MODIFICATION BULLETIN NO. 1 PAGE 1 OF 4

Model	DF 43	Volt/Hz	Date of Modification	Serial Number	
Modified Article		No serial numbrt cut in infotion			
Reason for Modification	Parts catalog correction

Modification Bulletin

Model: DF43	Date: 28-F	eb-97	No: 002	1/1	
Modified Article: Tapping Screw			Prepare	d by: K. Ugaeri	
From: QAC 2nd Fiel	ld Information Dept.		Checke	d by: S. Fujii	
Reason for Modification:	☐ Parts catalog correction☐ To facilitate assembly☑ Other	☐ Vendor ch	•	☐ To meet standards ()	3

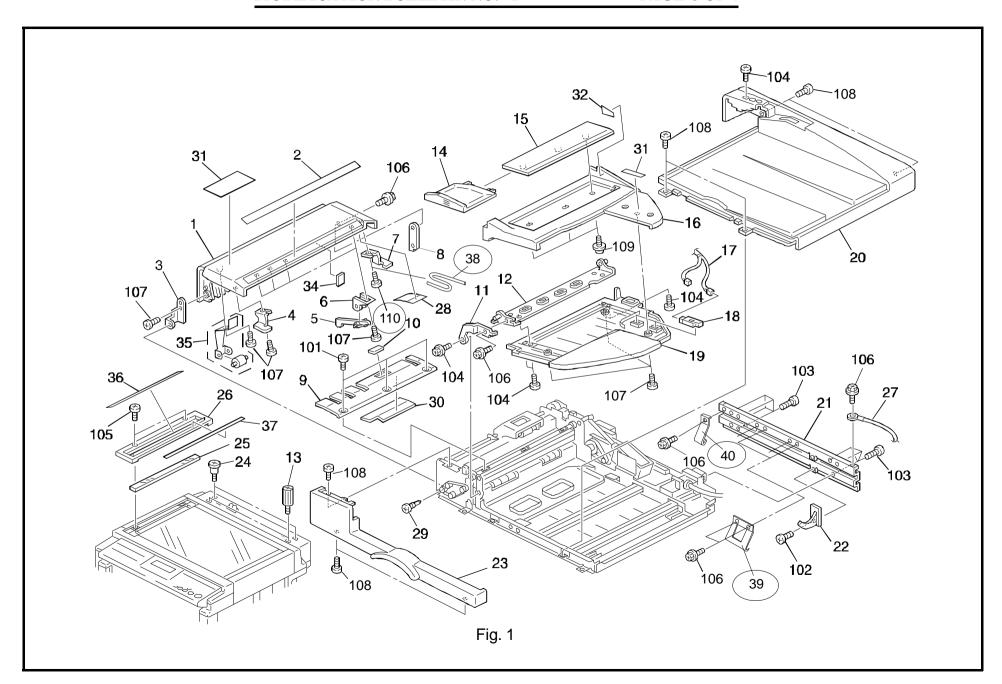
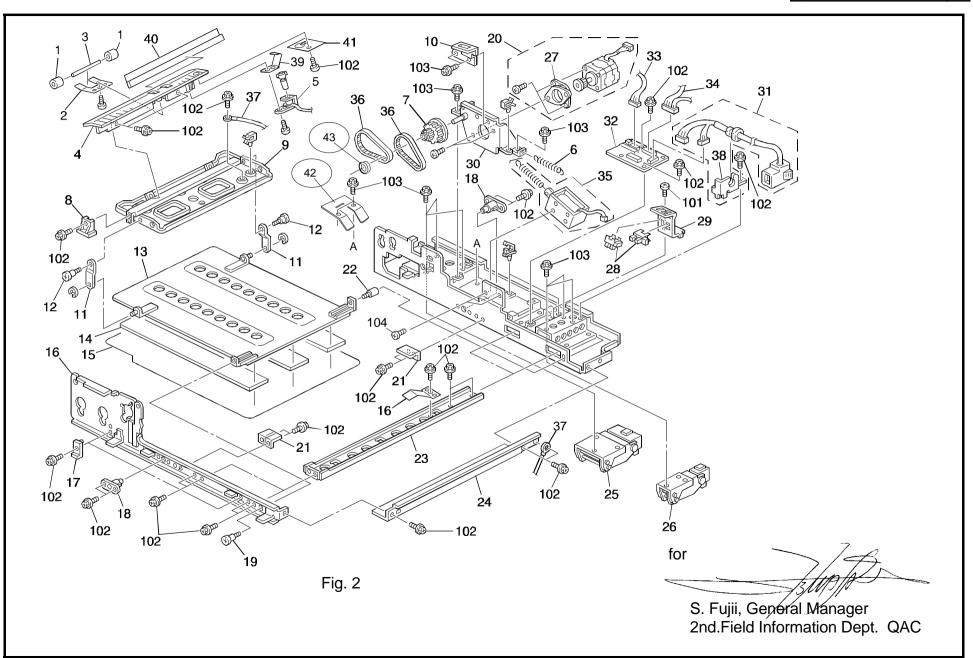
The following should be corrected. Please correct your part catalog.

1. The following parts have been modified.

2. The following parts have been added.

Old Part Number	New Part Number	Description	Q'ty	Index No.	Page
A6281236	A6281261	Original Entrance Guide	1	9	3
A6282167	A6281262	Pad - Original Entrance Guide	1	10	3
A6281217	A6281257	Original Feed Belt	1	18	5
AA063144	A6281596	Left Transport Roller Spring	4	38	5
A6281582		Rear Spring - Exit Roller	2 → 0	23	7
	→ G0101106	Spring - Interlock	2 → 4	40	7
A6281511	A6281512	Separation Roller	1	5	7
A6281572	A6281566	Rear Bushing - Exit Roller	2	22	7
A6281581	A6281585	Lower Exit Roller	2	24	7
A6281571	A6281565	Front Bushing - Exit Roller	2	25	7

New Part Number	Description	Q'ty	Index No.	Page	Fig. no.
A6282170	Lock Lever - Left Cover	1	38	3	1
A6281174	Right Grounding Plate - Hinge Bracket	2	39	3	1
A6281177	Left Grounding Plate - Hinge Bracket	1	40	3	1
04504010B	Tapping Screw - MX10		101	3	1
A6281176	Grounding Plate - Base	1	42	9	2
A6281829	Collar - 9X15X3	1	43	9	2

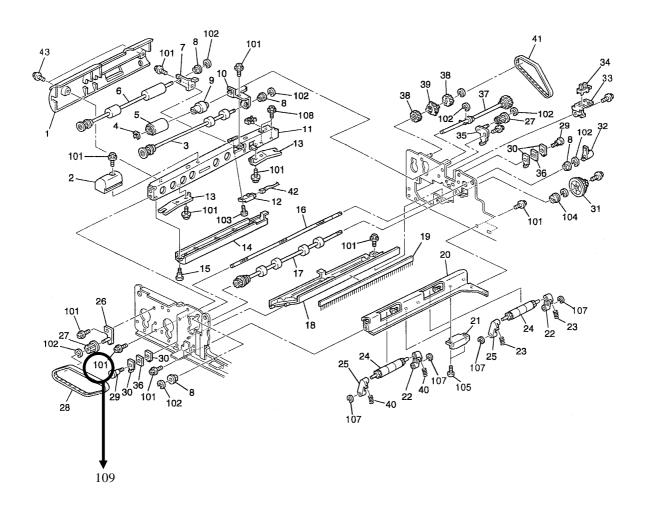
The Pull Out Guide (index 1 - A628 1541) may be bent by coming in contact with the screws. The length of the screws has been changed from 6 mm to 5 mm

Old part number	New part number	Description	Qty	Int	Page	Index	Note
04513006B		Tapping Screw - M3 x 6	4 - 0		6	101	
	04513005B	Tapping Screw - M3 x 5	0 - 4		6	109

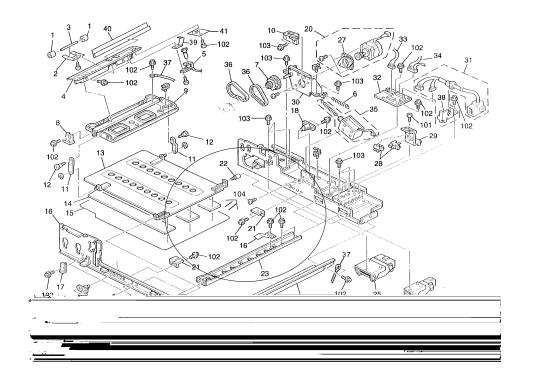
Model: DF43 Dat			Date	e: 19-Mar-97	No: 5	
Modified Article: Philips Pan Head Screw			Prepared by: K.Ugaeri			
From: QAC 2nd Field Information Dept.				Checked by: S. Fujii		
Reason for	□ Parts catalog correction	☐ Vend	dor ch	ange 🔲 To r	neet standards	
Modification:			☐ To improve reliability ()			
	☐ Part Standardization	☐ Othe	r

Old part	New part	Description	Qty	Int	Page	Index	Note
number	number						
03130040	A5902214	Philips Pan Head Screw - M3x4	2-2		9	104
